NAME	SIGNATURE	DATE
DRAWN BY	M.KARADELI		22.06.01
CHECKED	M.KARADELI		22.06.01
APPROVED	C.GÜLERYÖZ		22.06.01
SCALE	Item Name: 22.5x11.75

DRAWING NO  
117599

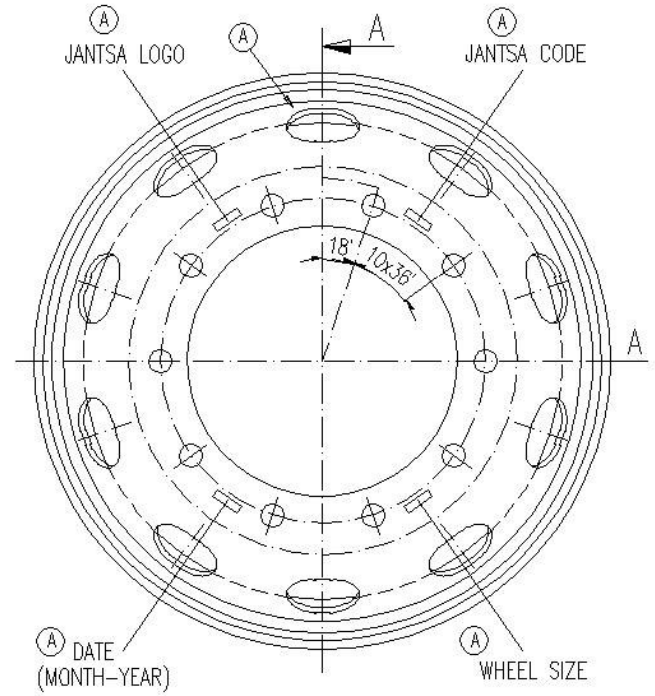
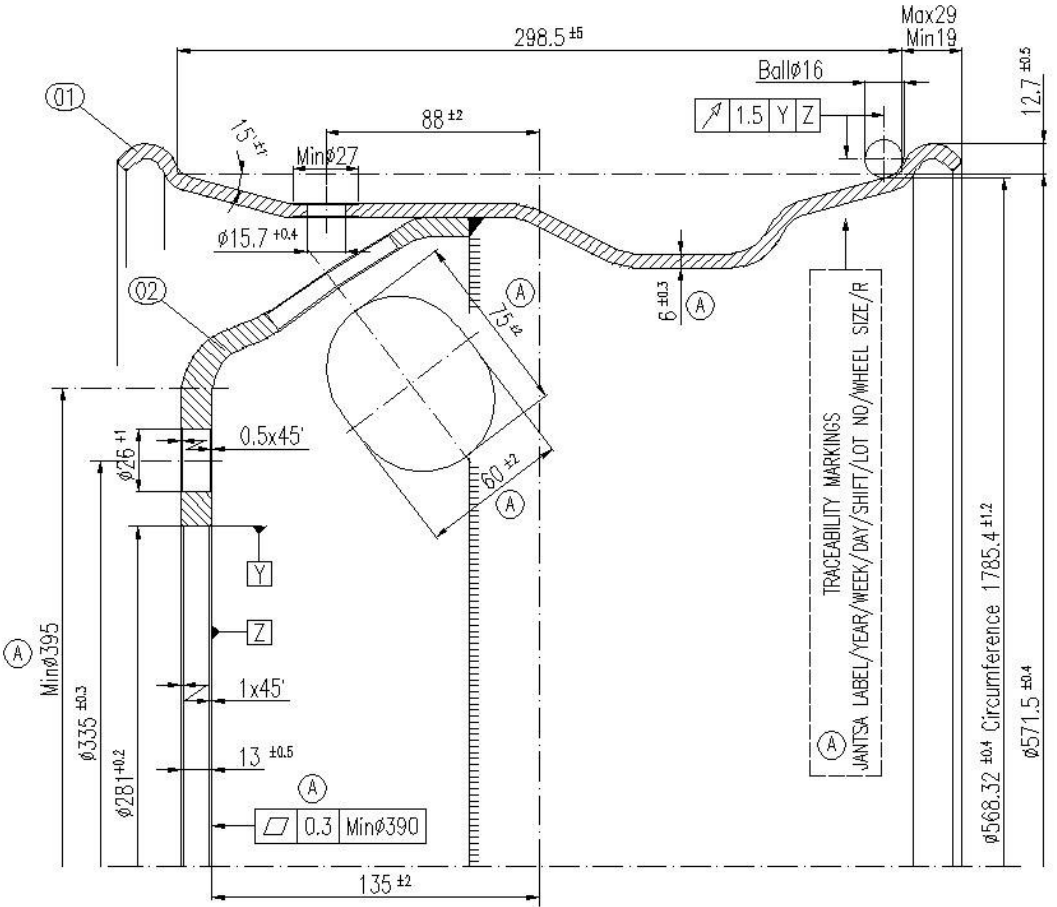
LETTER	DESCRIPTION	REVISION	DATE	REV.NO
(A)	Disc profile and ventilation hole changed. Markings added. Rim thickness and material changed. Now 6 mm St 44-2	Drawing is revised.	21.06.06	1
